1008 W. 41st Ave. & 5763 Oak  
St., VANCOUVER, BC

**UDP  
Presentation**

# OAK & 41st

# Response to Previous UDP Comments

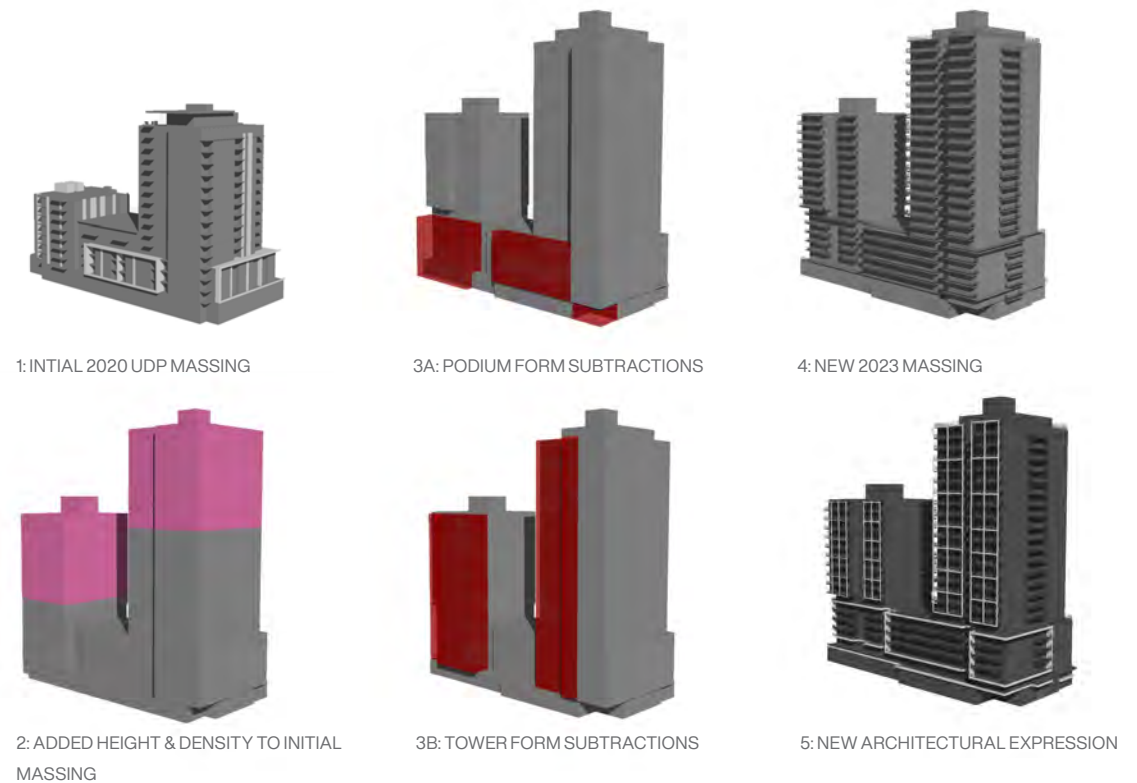
### 2. Design Development to podium expression and its relationship to the tower.

The architectural expression has been unified throughout the project. The vertical and horizontal frame form included in the initial concept has been reimagined and strengthened to provide a consolidated façade expression. Each building face features complimentary aspects of vertical and horizontal articulation.

The design has evolved to include metal panel aperture throughout the scheme, creating visual continuity between the podium and towers.

The podium expression features three distinct metal panel box elements that continuously frame Oak Street in a protruding and staggered manner, culminating at the prominent intersection on Oak Street & 41st Avenue. The laneway elevation also includes a central box element on the podium level, connecting it with the theme on the Oak Street frontage.

Strategic subtractions to the mid-sections of the buildings are utilized throughout the project and serve to setback the towers above, providing relief to the massing and generating visual interest. A rich, dark-coloured brick is introduced at-grade to help anchor the podium and provide texture at the pedestrian level.

SECTION: L1 PLAZA (42ND AND OAK)

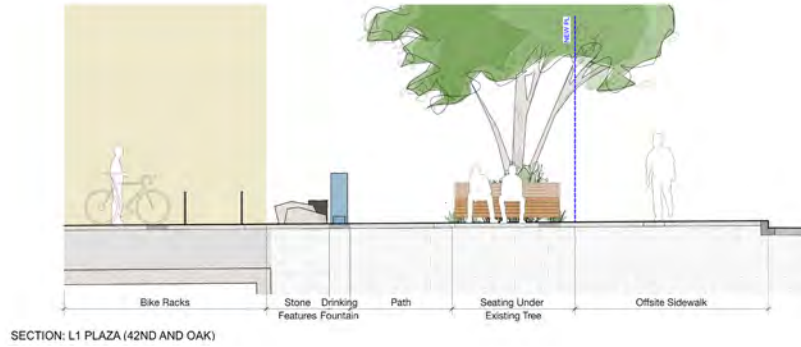
**3. Design Development to public realm and storefronts for opportunities to animate and increase the porosity; consider a small corner café use facing the 42nd Ave and [the] Oak sidewalk plaza.**

The public realm has been enhanced considerably and the project better accommodates the at-grade human scale of the project. The size of the corner plaza at Oak Street & 41st Avenue has increased, creating more opportunity for an active streetscape experience. The area offers ample room for interesting seating and other furnishings, varying materiality, thoughtful hardscape and landscape, and potentially public art.

There remains to be an openness to varied retail use and programming, along with a commitment to fostering a sense of community and providing nodes for gathering on the street level.

A bold gridded sidewalk pattern has been included, with repeating attractive modern benches along Oak Street. These seating areas will benefit from the canopies provided by the 4 mature street trees that have been retained along the Oak Street frontage.

Retail canopies provide weather protection and the opportunity for retail identification and enhanced architectural expression on the street level. The use of lighting on canopies, soffits, and building faces will assist with placemaking at-grade, while also enhancing CPTED. Retail storefronts will feature expansive glazing to allow for interaction between the interior of the building and the streetscape.

Public realm render looking at the corner of 41st Avenue & Rear Lane

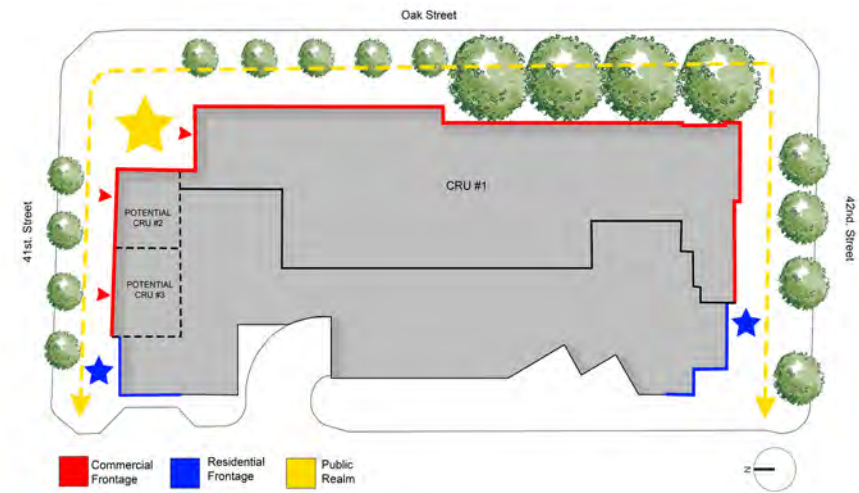
**4. Design Development to animate, activate and green the lane frontage, and improve the relationship to the single family residential to west. Review the parking ramp location to align with lane to the west (behind the RS1 zoned properties).**

While the laneway design has been revised to feature an architectural expression more consistent with the other building faces, it offers a slightly more muted appearance with careful consideration of the nearby single-family homes.

The podium level includes one central metal box frame and features a significant setback on the 2nd level where one of the two amenity roofs is located. This serves to break-up the massing on the laneway and punctuate the design.

Glazing wraps the northwest residential lobby, activating the laneway and increasing the CPTED on that plane by increasing the 'eyes on the street' and illumination in the area.

Ample plantings on the Level 2 green roof amenity soften the relationship at the laneway, as does the addition of horizontal wall plantings fronting the laneway, where care has been taken to increase soil depth for this greenery.
